KA 690-10-03
January 4th, 2011

Re: Initial Title V Air Operation Permit Application – Project No. 1190042-007-AV
American Cement Company, LLC
Sumterville Cement Plant
Request for Additional Information

File No. 5501010001

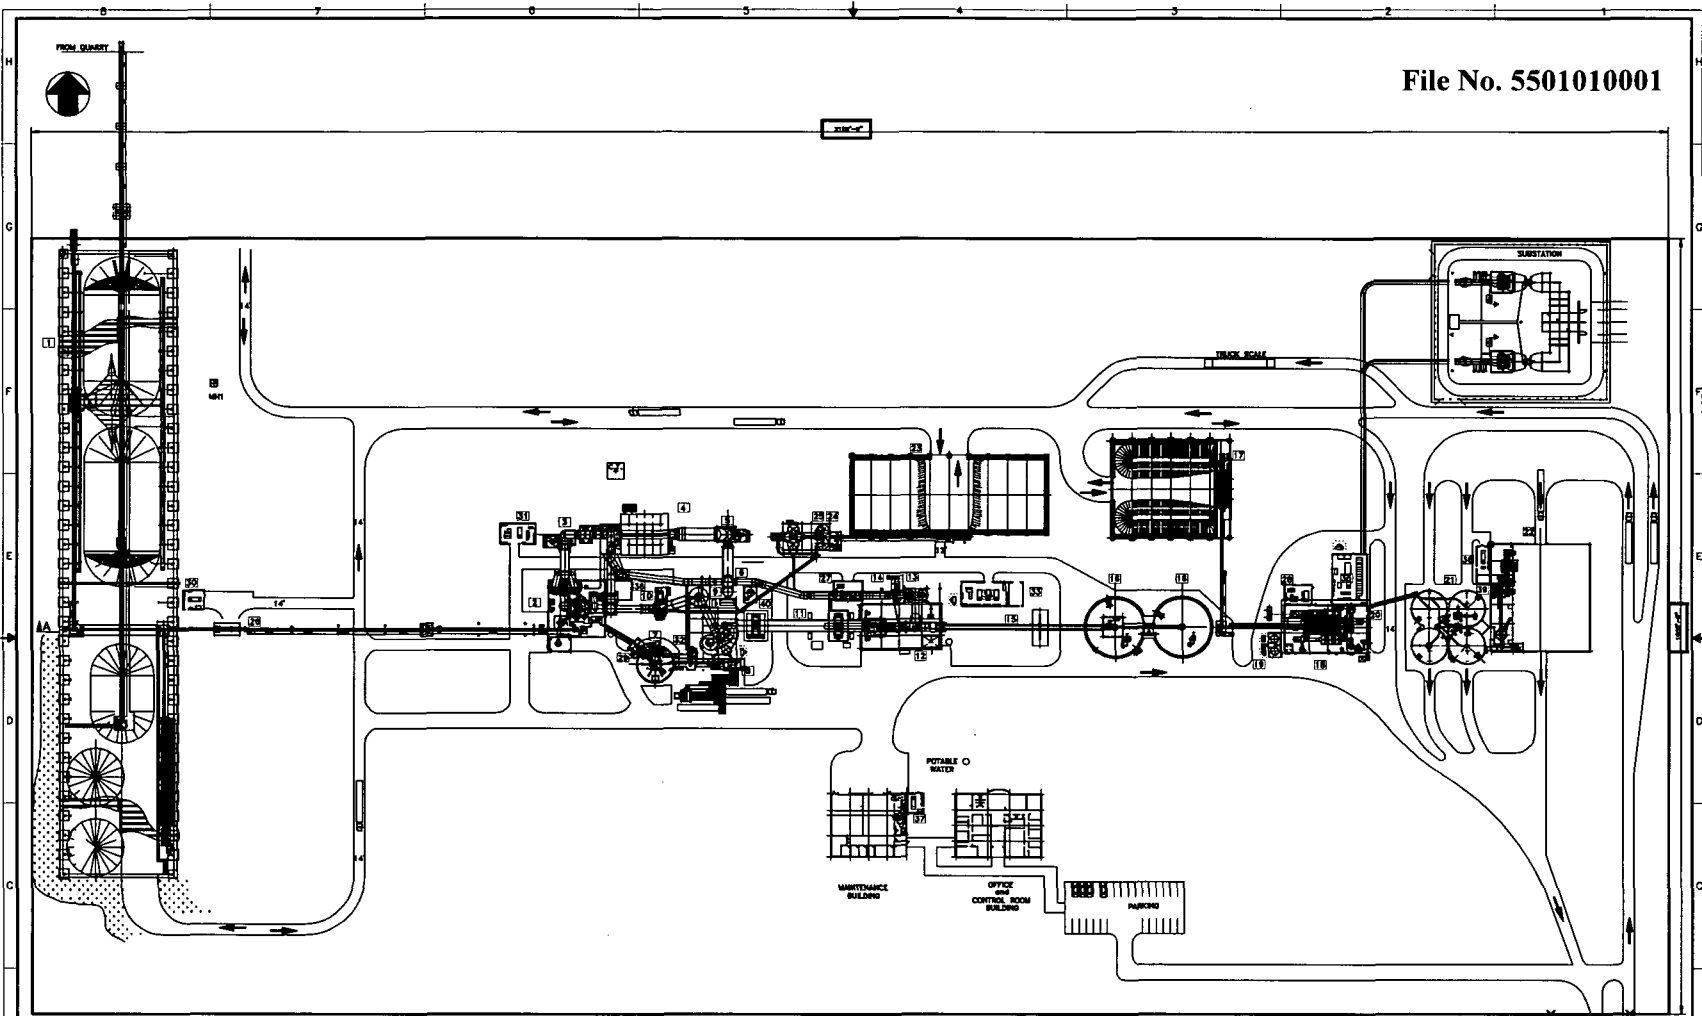
1. Facility Process Flow Diagram Attachment – The Facility Process Flow Diagram attached to the application shows the facility as having separate wet process and dry process equipment ahead of the rotary kiln. It also shows an Optional Preheater/Precalciner or an Optional Preheater as part of the Dry Process. Based on information obtained during a site visit, the facility is using only a dry process (i.e., there is no wet process equipment) and is equipped with a preheater/precaciner as part of the dry process. Please resubmit the Facility Process Flow Diagram correcting/clarifying the items noted above, and making any other corrections/clarifications needed to accurately represent the facility process flow as it was actually built and is being operated.

Facility Process Flow Diagrams have been attached to show actual processes. See attachment 2 for details.

ATTACHMENT 3
KILN & COOLER CONSTRUCTION DATE

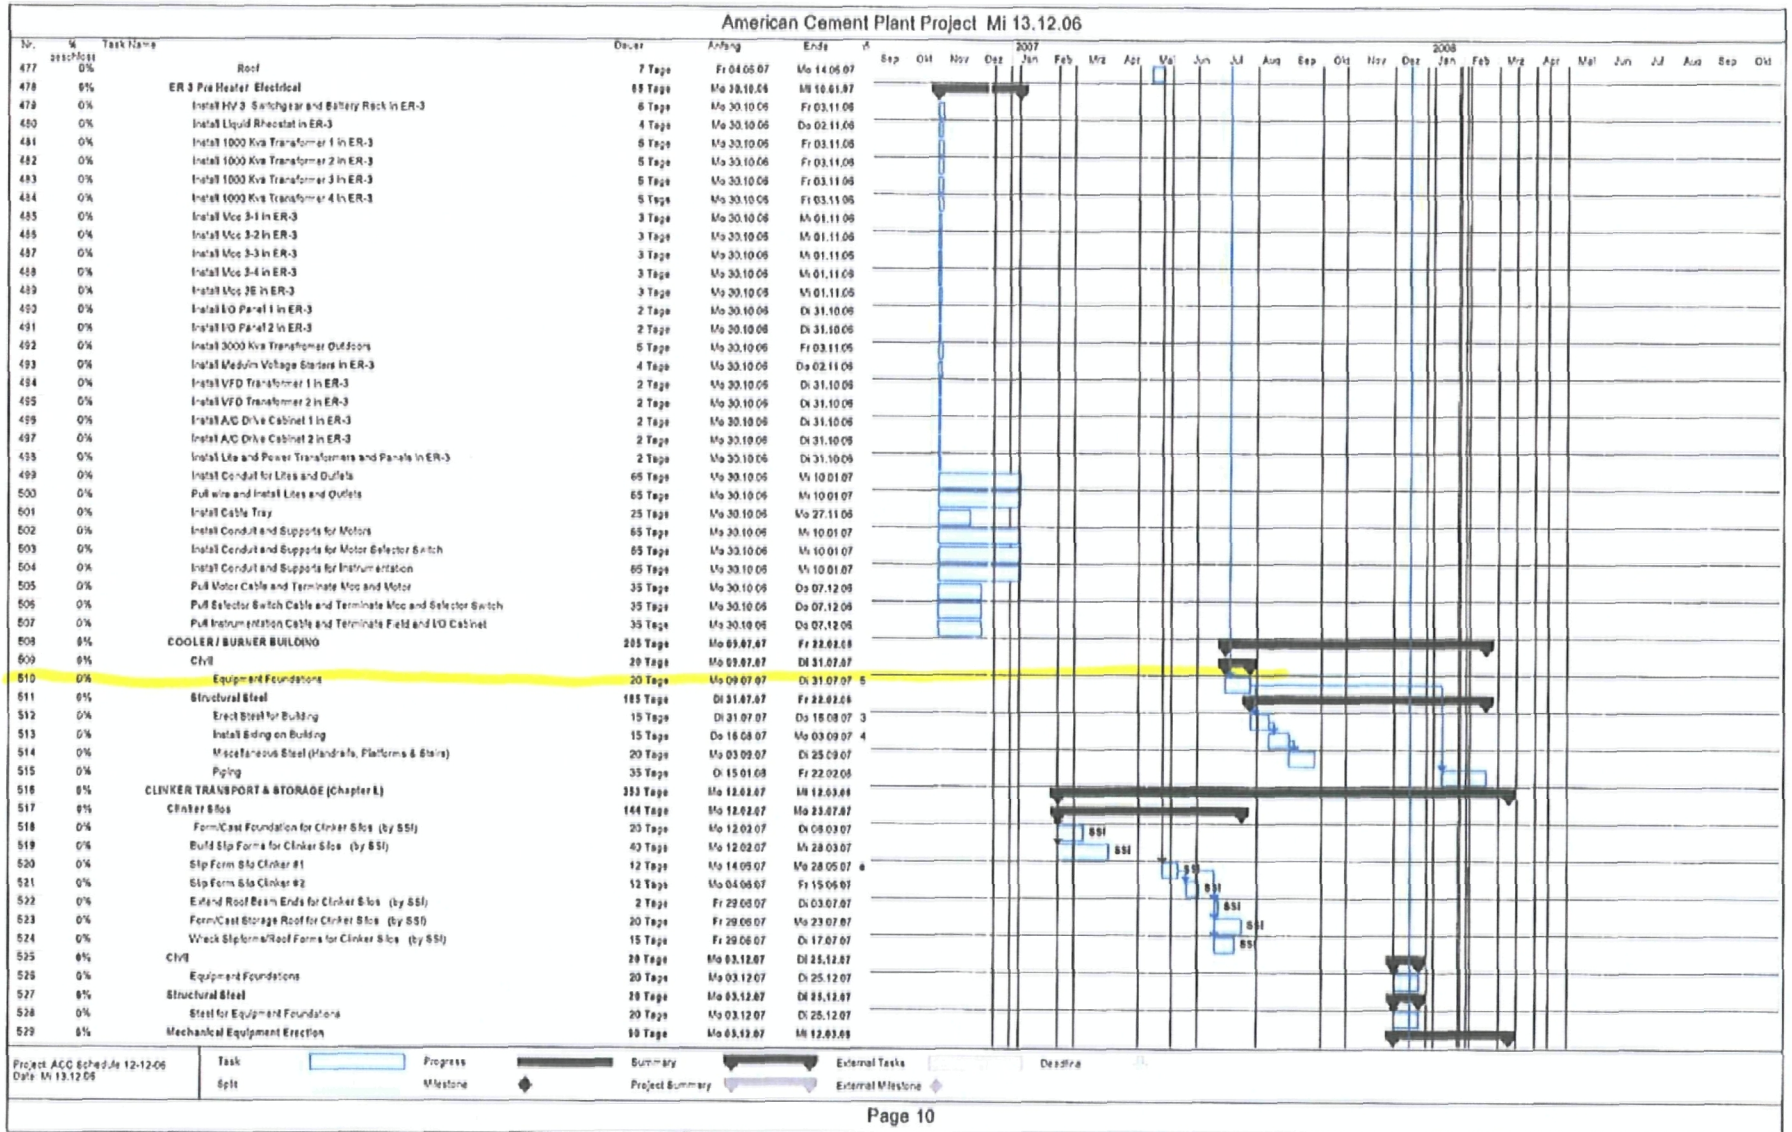
2. NSPS Subpart F Applicable Requirements - NSPS 40 CFR 60 Subpart F as amended in the September 9, 2010 Federal Register (effective date of November 8, 2010 , which will be prior to the effective date of the initial Title V operation permit for this facility) has additional requirements for kilns and clinker coolers for which construction

commenced after June 16, 2008. In order to confirm whether these requirements are applicable to this facility, please provide the date(s) of commencement of construction for the kiln and for the clinker cooler and the basis for these dates.

The actual commencement of construction date for the Kiln is March 13, 2007; Gantt Chart line 417 for Preheater Foundations.

The actual commencement of construction date for the Cooler is July 9, 2007; Gant Chart line 510 for Cooler/Burner Building Foundations.

ATTACHMENT 4
QUARRY & RAW MATERIAL STORAGE CONSTRUCTION DATE

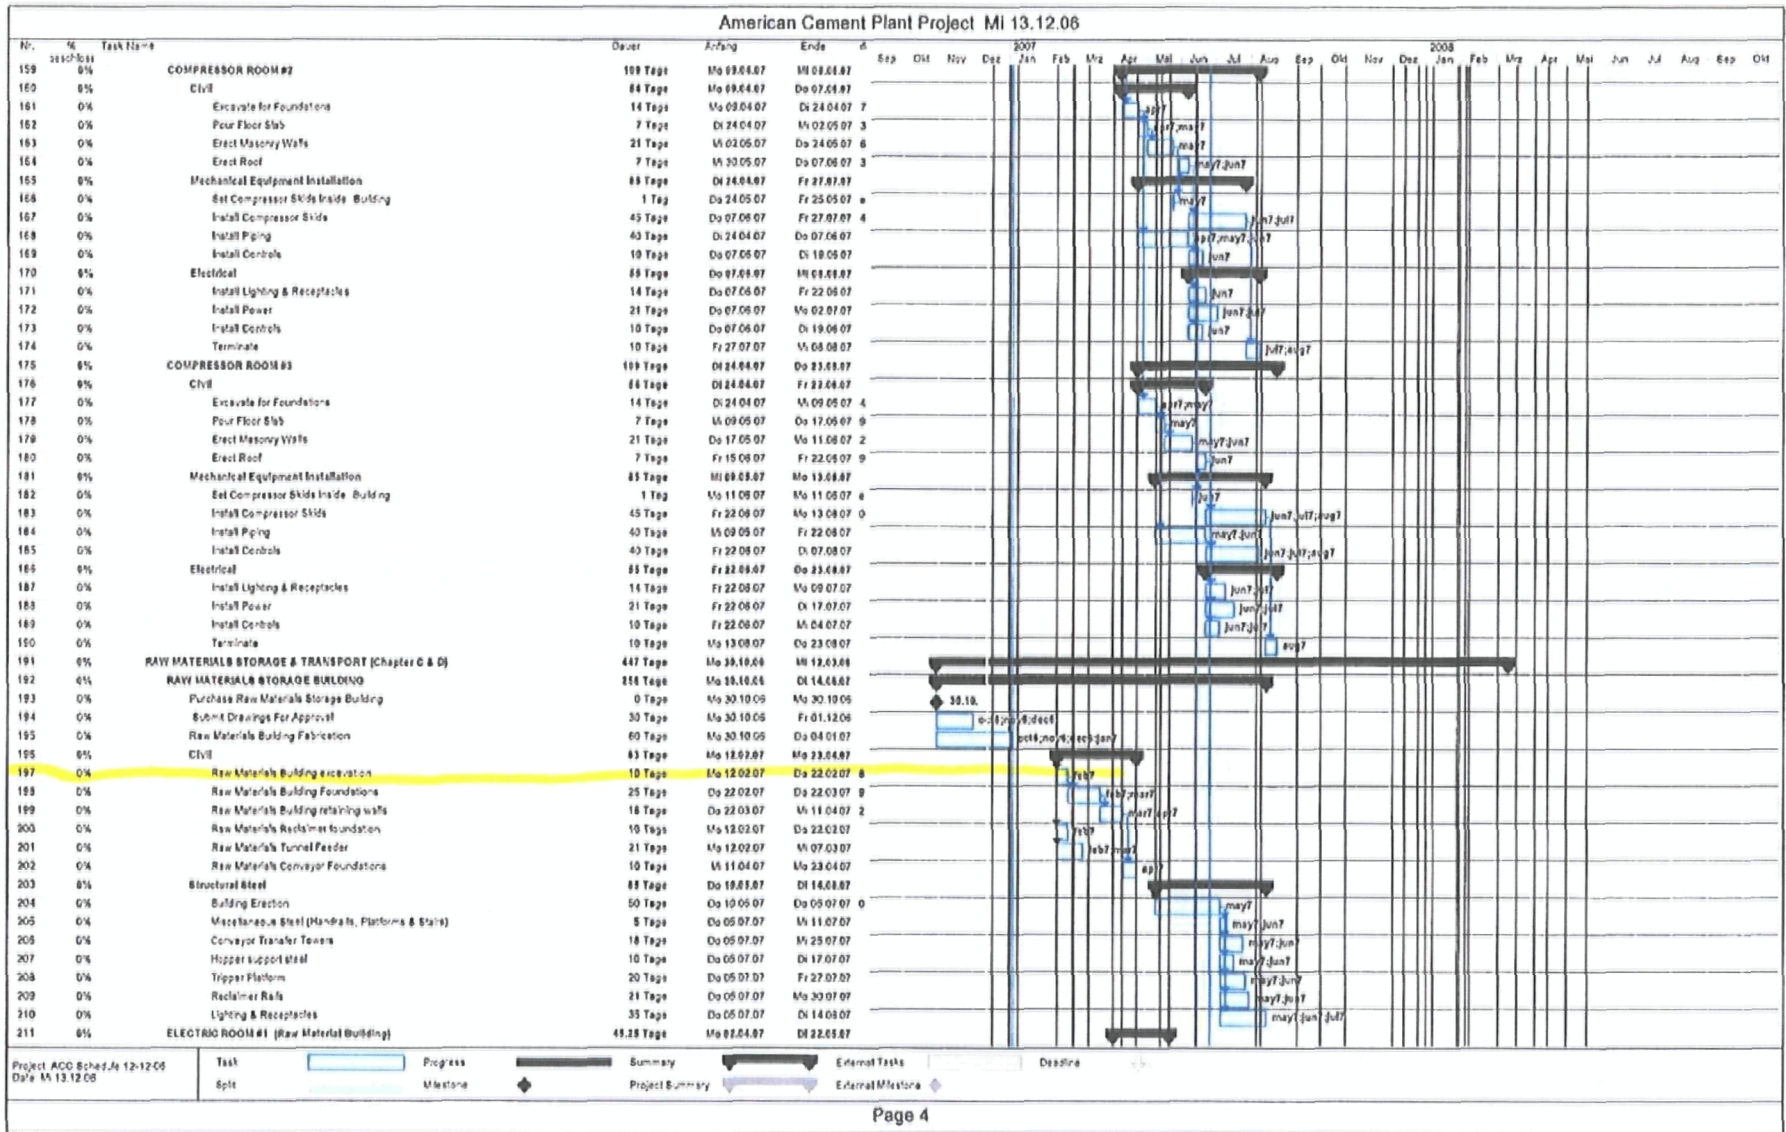
3. Subpart OOO Applicable Requirements - NSPS 40 CFR 60 Subpart OOO (Standards of Performance for Nonmetallic Mineral Processing Plants) is applicable to EU 001 (Raw Material Quarrying, Crushing and Storage). This is not reflected in the application, as an identification of applicable requirements attachment was not provided for EU 001. Please provide such attachment. (See also Note below item 4. below.) Subpart OOO, as amended in the April 29, 2009 Federal Register, has additional requirements for mineral processing equipment for which construction commenced on or after April 22, 2008. In order to confirm whether these requirements are applicable to any of the non-metallic mineral processing equipment at this facility, please provide the date(s) of commencement of construction for the limestone processing, storage, and handling equipment at this facility and the basis for these dates.

The actual commencement of construction date for the Raw Material Storage is February 12, 2007; Gantt Chart line 197 for Raw Material Building excavation.

The commencement of construction date for the Quarry is not specified, but the Request for Change Order dated October 18, 2007 with attached schedule shows active construction in the Quarry.
